Amdt. dated December 7, 2005

Reply to Office Action dated June 7, 2005

REMARKS

FIG. 6

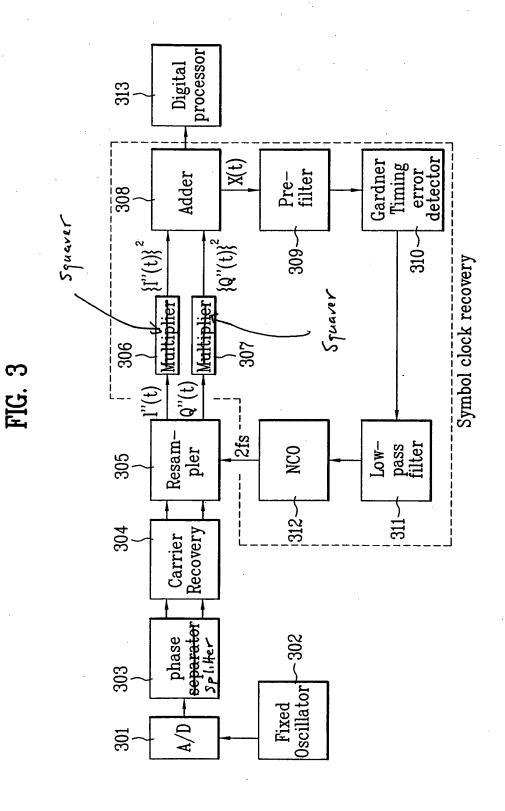
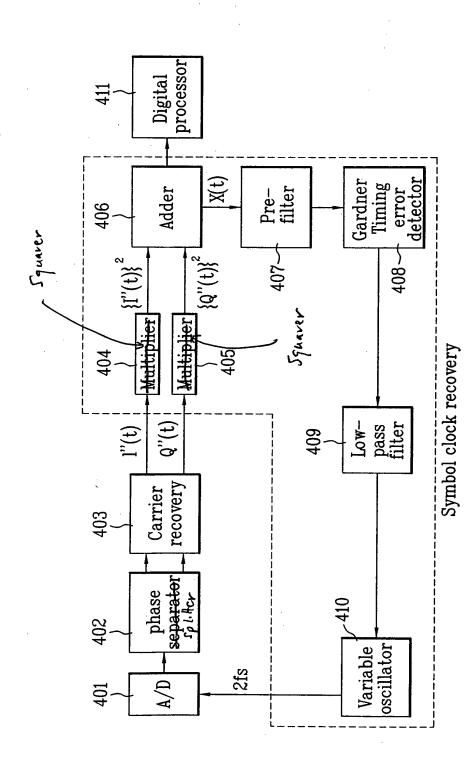
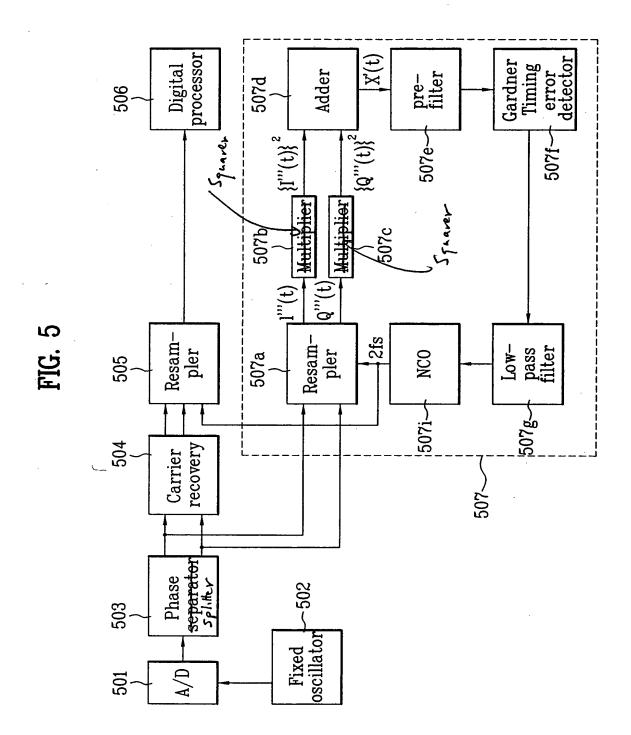
The Office Action objects to the term "phase separator" in Figs. 3-7. Figs. 3-7 have

Further, the Office Action objects to the drawings because certain reference numerals

specified in the drawings do not comport with the specification, or are not set forth in the

been amended to replace the term "phrase separator" with the term "phrase splitter." Figs. 3-6

have been further amended to replace the term "multiplier" with the term "squarer."

specification. The specification has been amended so that the reference numerals now comport
